DRAINAGE COMPLIANCE LETTER

Date: September 8, 2025

Subject: **7 Brew – Lincoln Professional Park Filing No. 1, Lot 2**

SHEET
296237001_DM

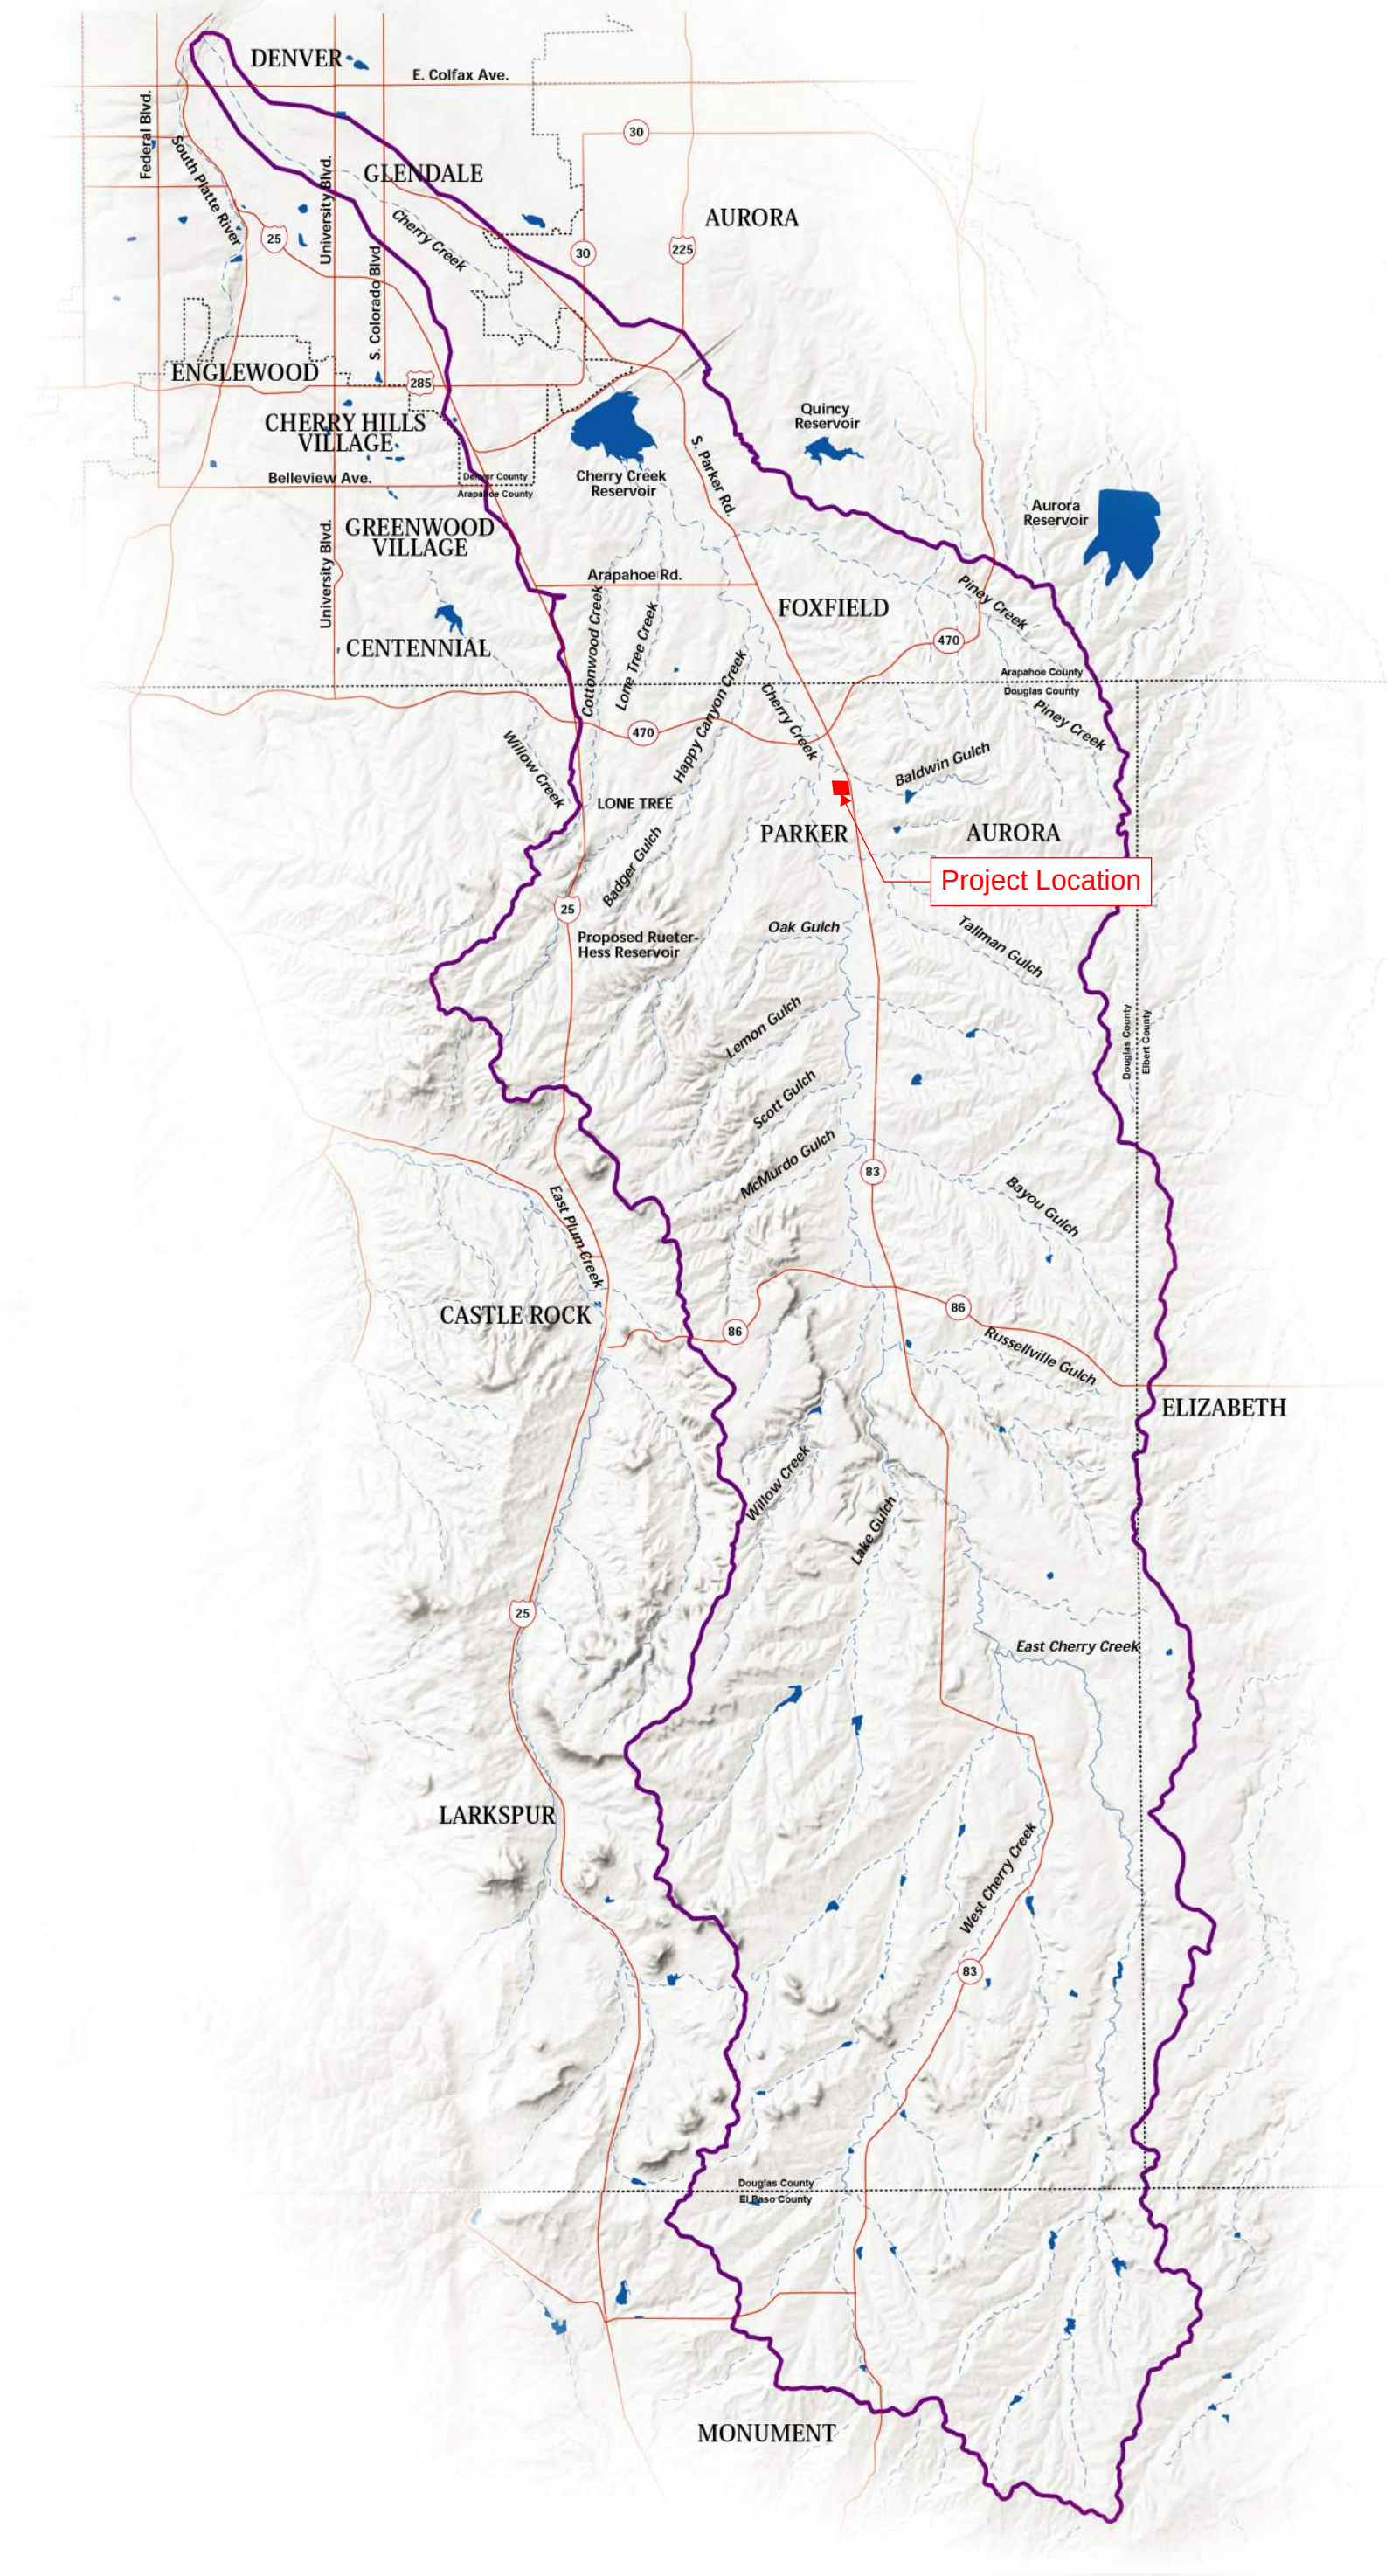
Please include hydraulic calculations for pipe sizing and HGL's for the minor and major storm events. (See Section 6.3.3.4 of the SDECM for Hydraulic Design Requirements)

KH Response:
Inlet capacity calculations provided in Appendix D of the Drainage Compliance Letter. Updated calculations per the latest design changes have been included in the same location.

KH Response:
Hydraulic calculations for pipe sizing and the HGL's for the minor and major storm events has been included in the Drainage Compliance Letter.
